Subject: Installation of a pneumatic tailwheel in exchange for the tailskid.

Affected gliders: All K 8s.

Fig. 1

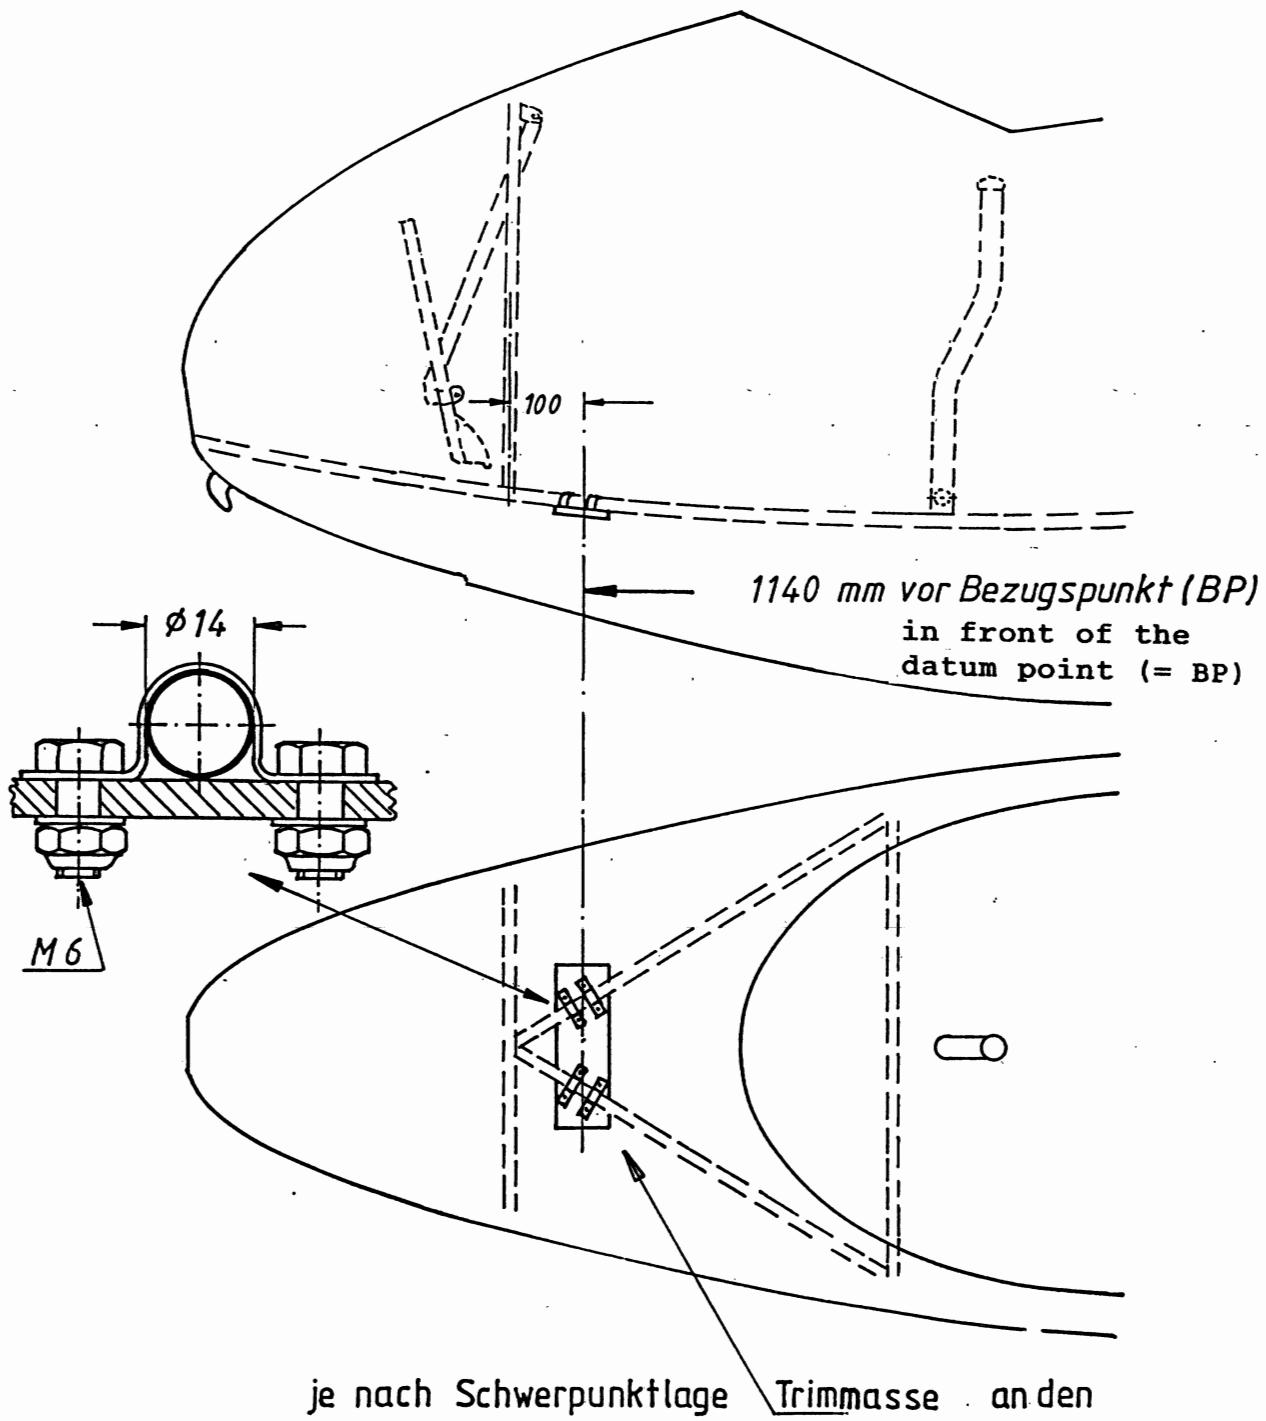
Action: According to drawing "Installation of pneumatic tailwheel" dated Feb.1, 1986, the fuselage is modified and the tailwheel installed. Depending on the new C.G. position a corresponding trim mass must be fixed in the fuselage nose below the front foot panel (see Fig.1).

Mass and C.G.: Owing to this modification the mass of the non-lift producing parts is increased by approx. 250 g and the C.G. is moved back by approx. 3 mm (0,12 in). Therefore, it is necessary to redetermine the mass and C.G. data. If the result of the C.G. weighing shows that the permissible C.G. range is exceeded, the short mass must be calculated and a corresponding trim weight must be fixed in the fuselage nose (see Fig.1).

According to the measured C.G. data the corresponding trim mass must be fixed at the bracings below the foot panel!
